# **GSI-191**

## **Treatment of Coatings Debris**

December 20, 2006

Matthew Yoder  
Office of Nuclear Reactor Regulation

## Logic to Determine Debris Generation from Unqualified Coatings

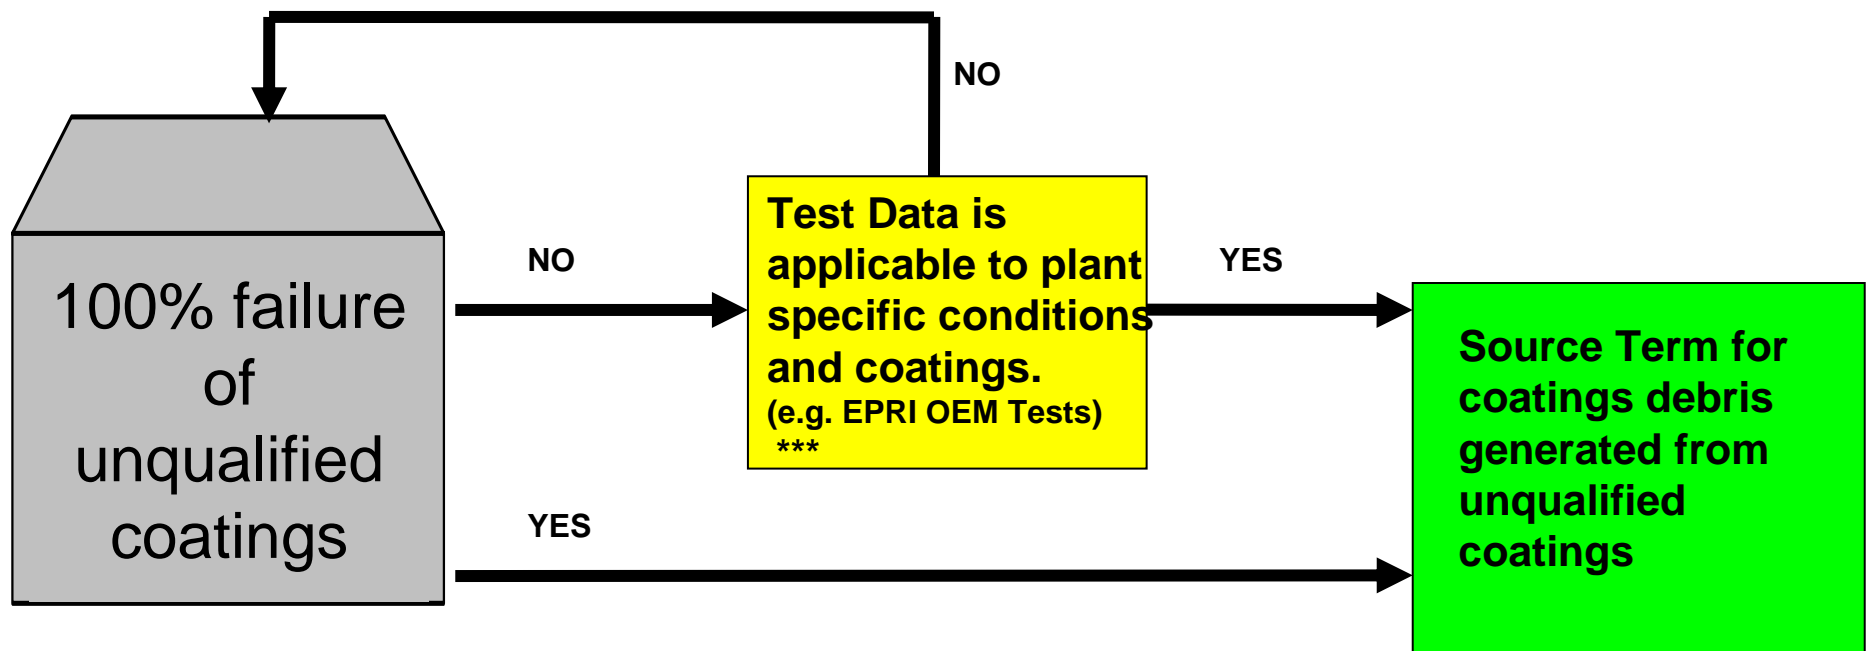
\*\*\*Note that NRC has not completed its review of this testing. Licensees may need to address technical issues in order to credit test results in their analysis.
